7.6 All Other Instrumentation Systems Required for Safety

The information in this section of the reference ABWR DCD, including all subsections, tables, and figures, is incorporated by reference with the following departures and supplements.

Figure 7.6-4a Basic Configuration of a Typical Neutron Monitoring System Division

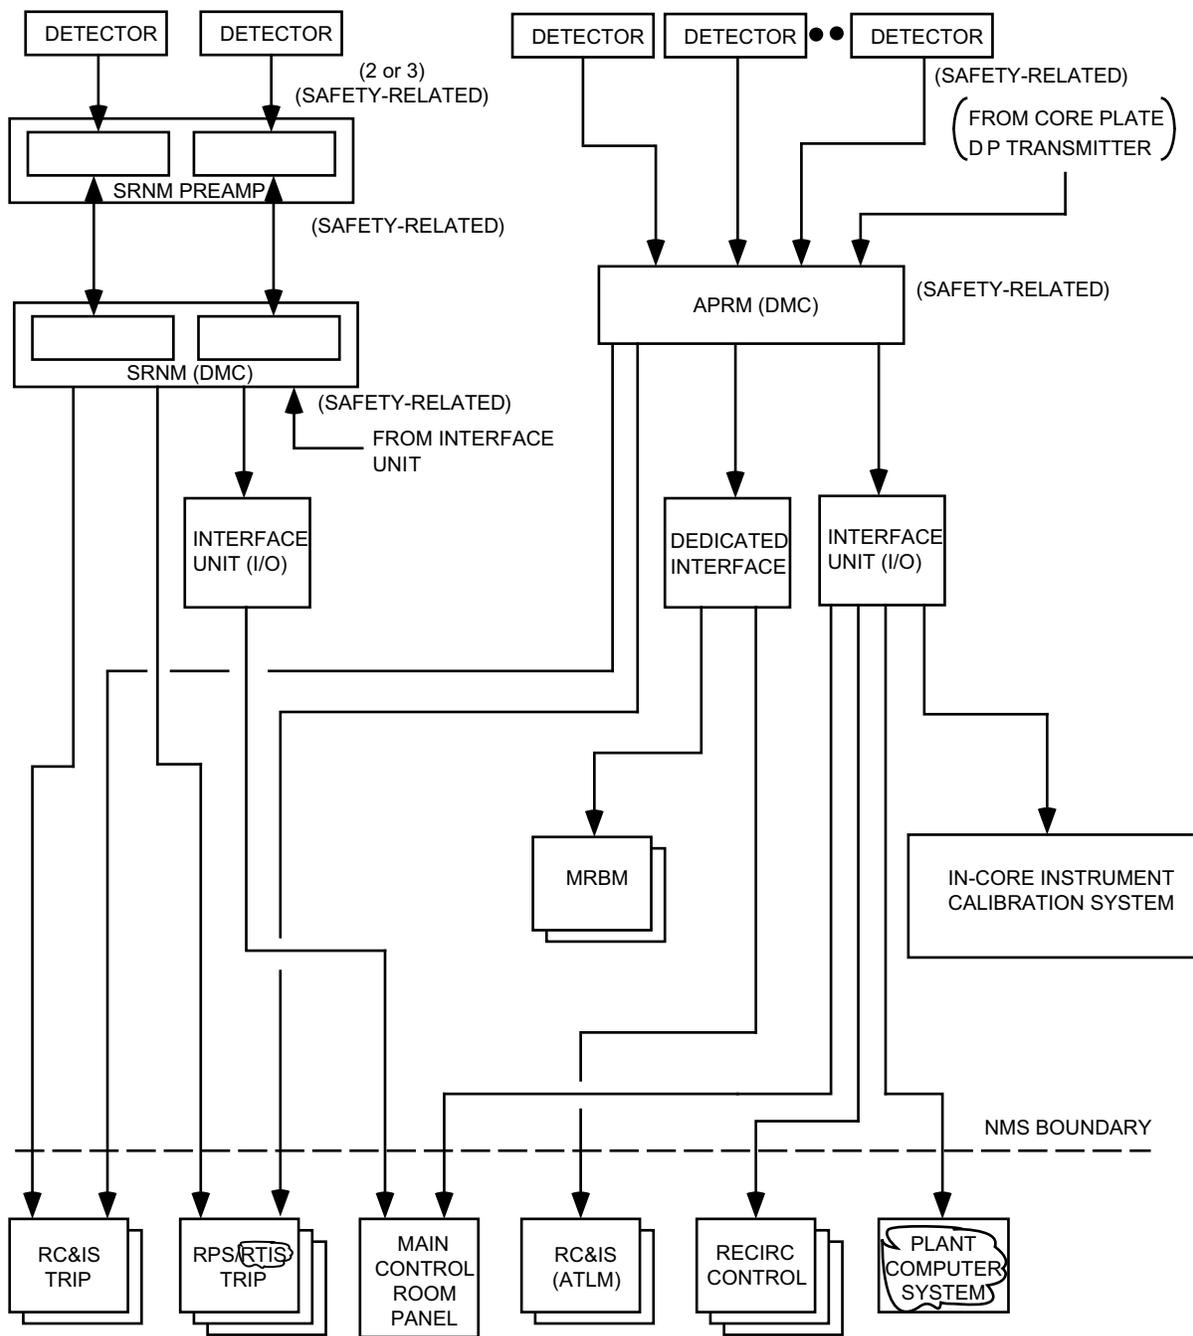
STD DEP T1 3.4-1 (Table 7.6-5 and Figures 7.6-1, 7.6-2, 7.6-4a)

The purpose of the Neutron Monitoring System (NMS) is to monitor power generation and, for the safety function part of the NMS, to provide trip signals to the Reactor Protection System (RPS) to initiate reactor scram under excessive neutron flux (and power) increase condition (high level) or neutron flux fast rising (short period) condition. The NMS also provides power information of operation and control of the reactor to the Plant ~~Process Computer System (PCS)~~ Functions (PCF) and the rod block monitor. A block diagram showing a typical NMS division is shown in Figure 7.6-4a. The operating ranges of the various detectors are shown in Figure 7.6-4b.

Figure 7.6-9 Instrumentation Location Definition for the Suppression Pool Temperature Monitoring System

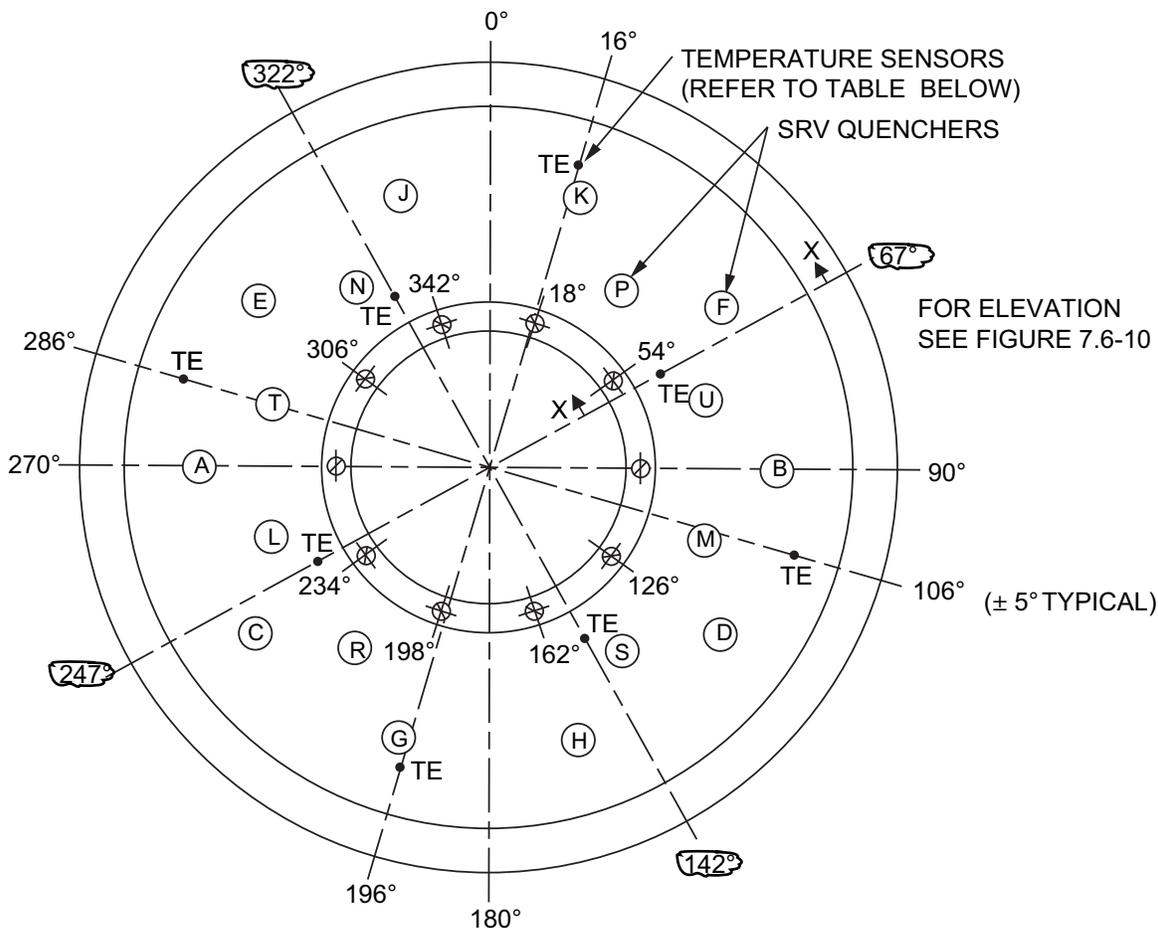
STD DEP 7.6-3 (Figures 7.6-9, 7.6-11, 7.6-12)

The SPTM System configuration is shown in Figures 7.6-9 and 7.6-10. There are eight temperature circumferential sensor locations (Figure 7.6-9), which are chosen based upon the following considerations:

Electrical wiring for each sensor is terminated, for sensor replacement or maintenance, in the wetwell. This termination is sealed for moisture protection from condensation or wetwell sprays. Division I, II, III and IV sensors are wired through Division I, II, III or IV electrical penetrations, respectively. ~~Division I, II, III or IV~~ I and II sensor signals are wired to for the Remote Shutdown System are directly hardwired. ~~all~~ All other sensor signals are transmitted ~~multiplexed~~ to the main control room via the respective Division I, II, III or IV essential- ~~multiplexers~~ Data Communication Function (DCF).

Figure 7.6-14 OPRM Logic

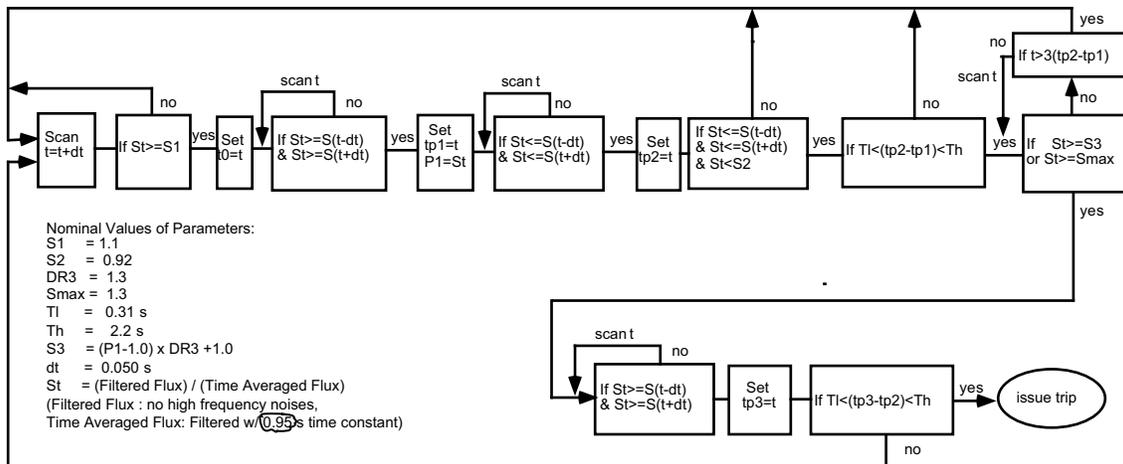
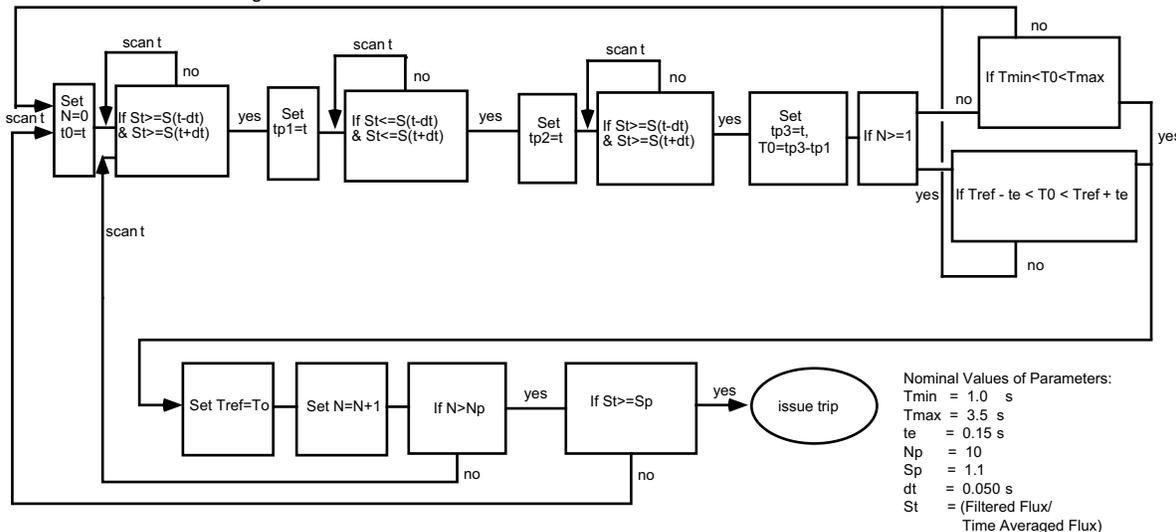
STD DEP 7.6-1 (Table 7.6-2 and Figures 7.6-2, 7.6-14)

~~For the OPRM trip function, the response signal of any one OPRM cell that satisfies the conditions and criteria of the trip algorithm will cause a trip of the associated OPRM channel. Figure 7.6-14 illustrates the trip algorithm logic. The OPRM trip function does not have its own inoperative trip for insufficient number of total LPRM inputs in the channel. It follows the APRM's inoperative trip of insufficient number of LPRMs.~~ The OPRM function has its own inoperative trip when the channel has less than the required minimum operable cells, or there is an OPRM self-test fault, or the APRM instrument firmware/software timer has timed out, if there is a loss of power to the APRM instrument.

T_{min}=1 s, T_{max}=3.5 s, ±t_{error}=0.15 s 0.1 N_p=10.
(For details see Figure 7.6-14).
